Addendum 5: Relocated utility panel and relocated light

This addendum is to show a change to the utility panel location and a change in location of a light pole.

SITE LIGHTING PLAN

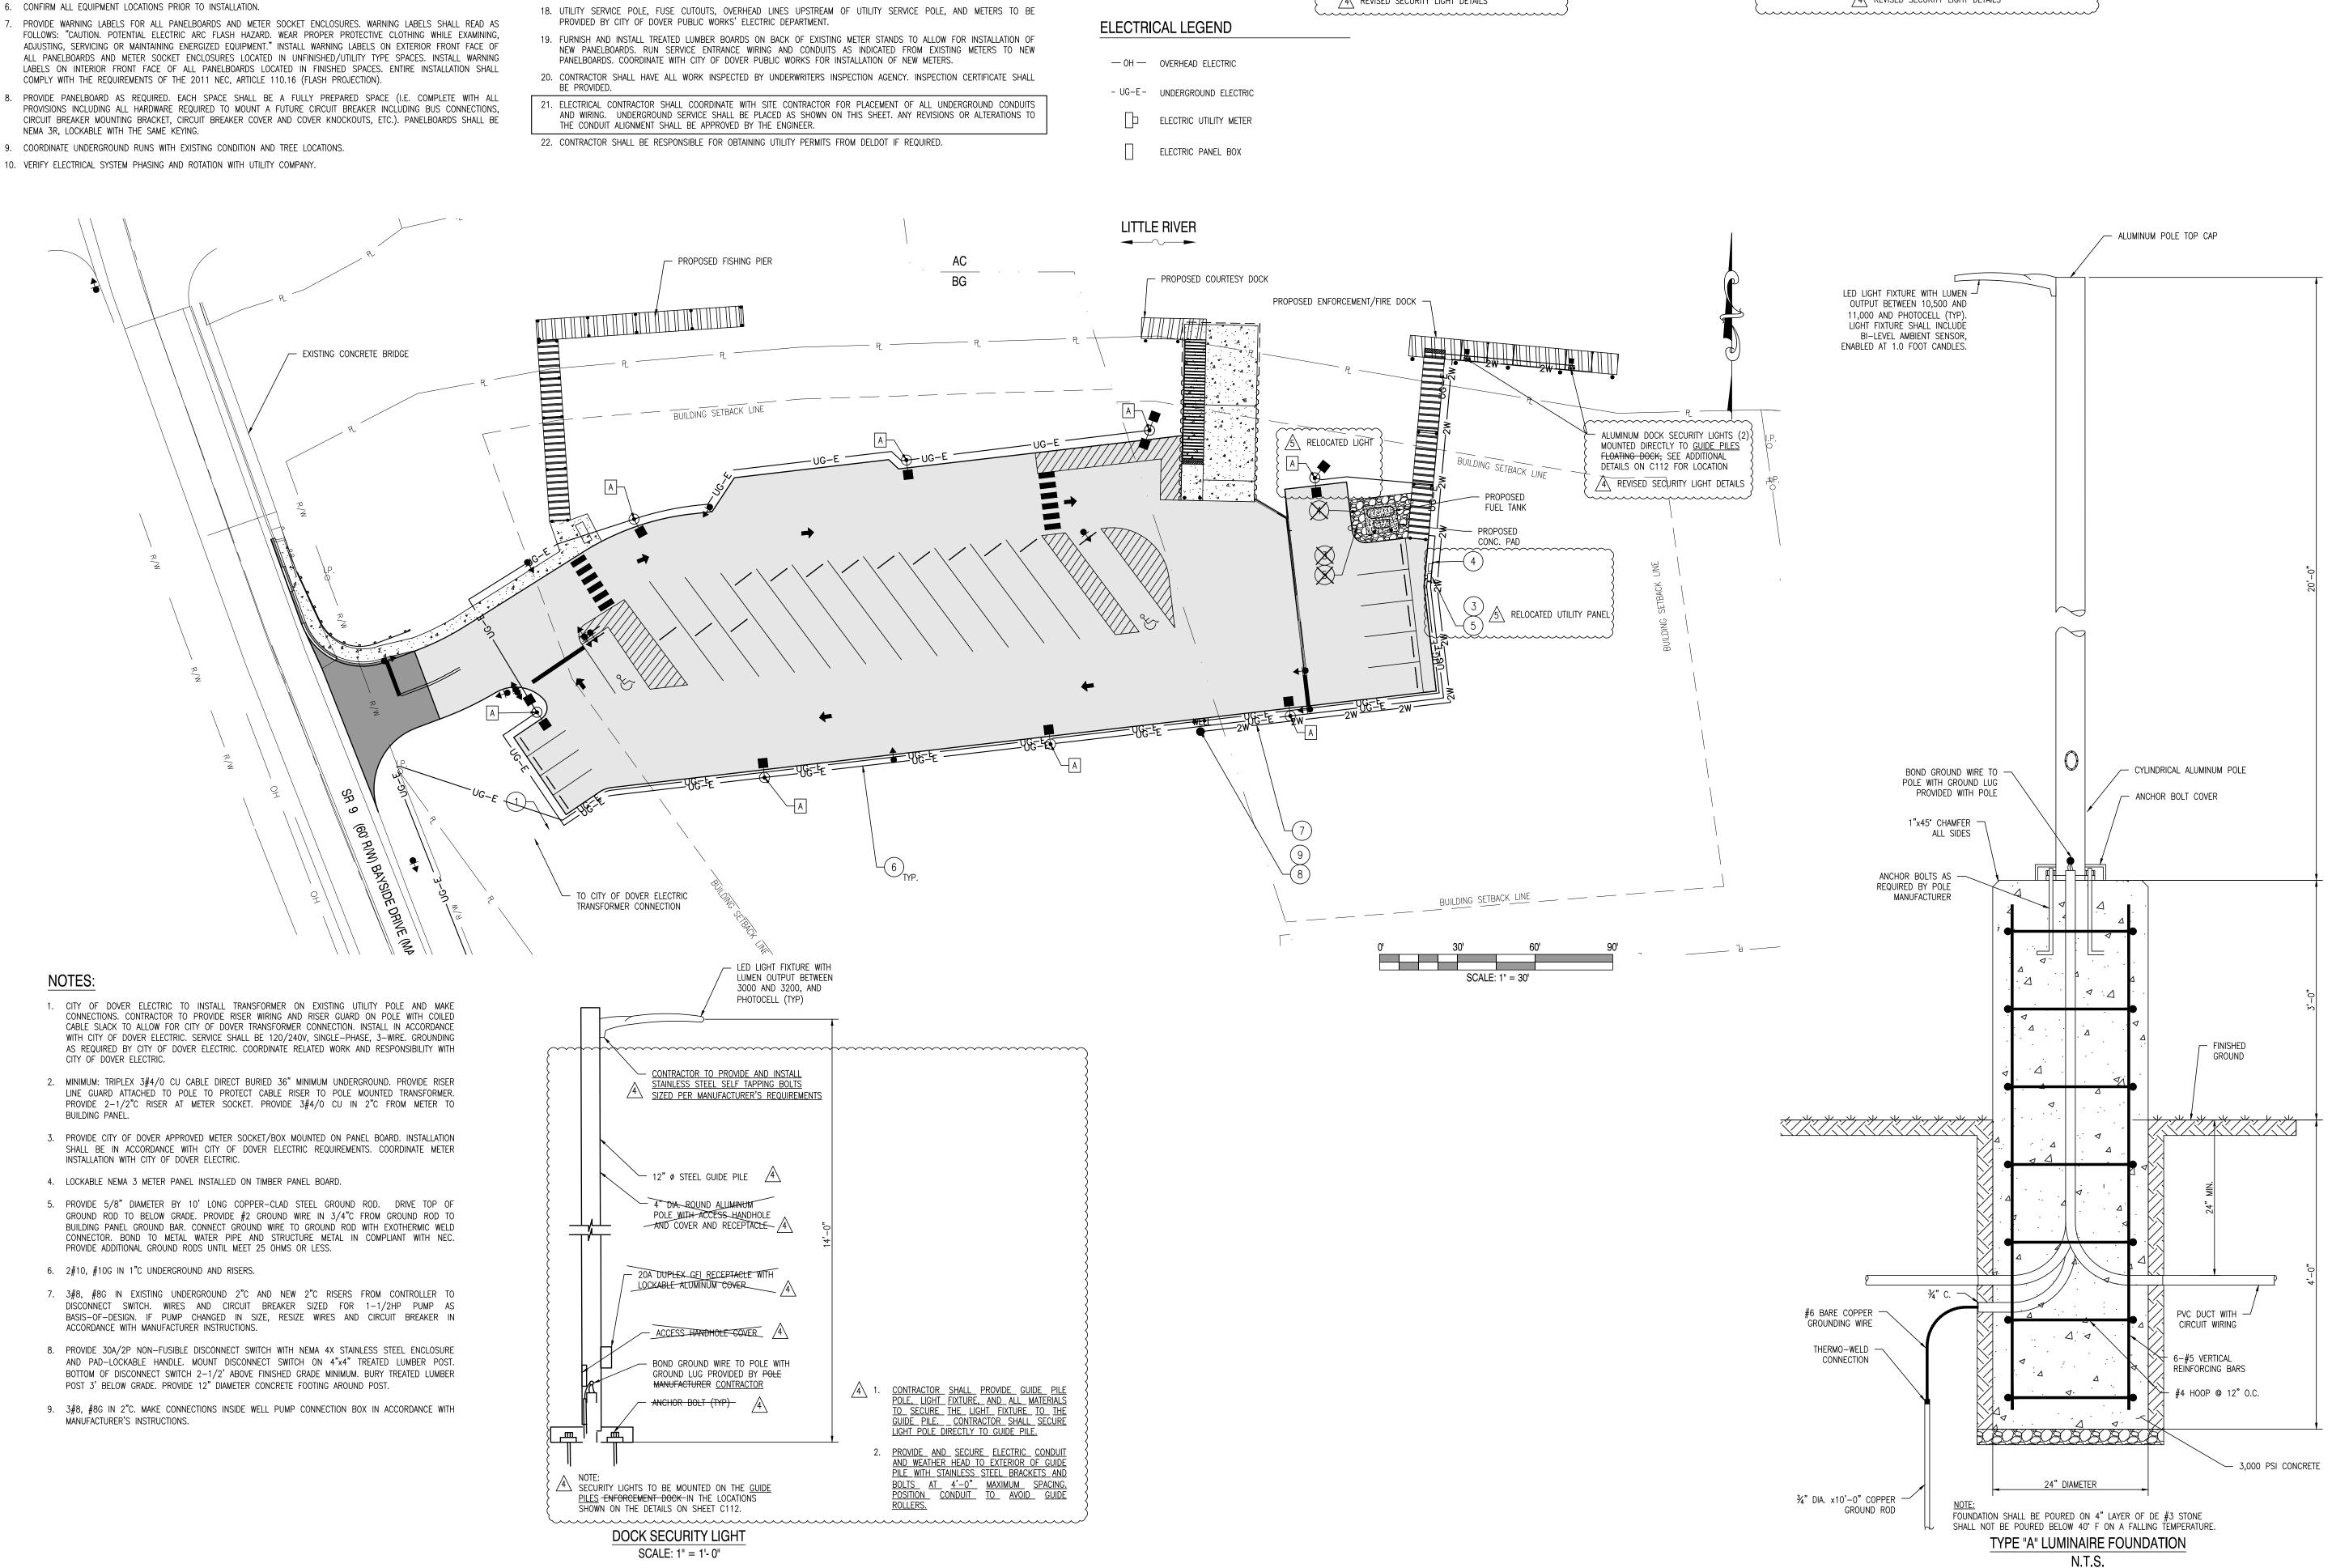
RELOCATED UTILITY PANEL & 02/14/2018
LIGHT POLE
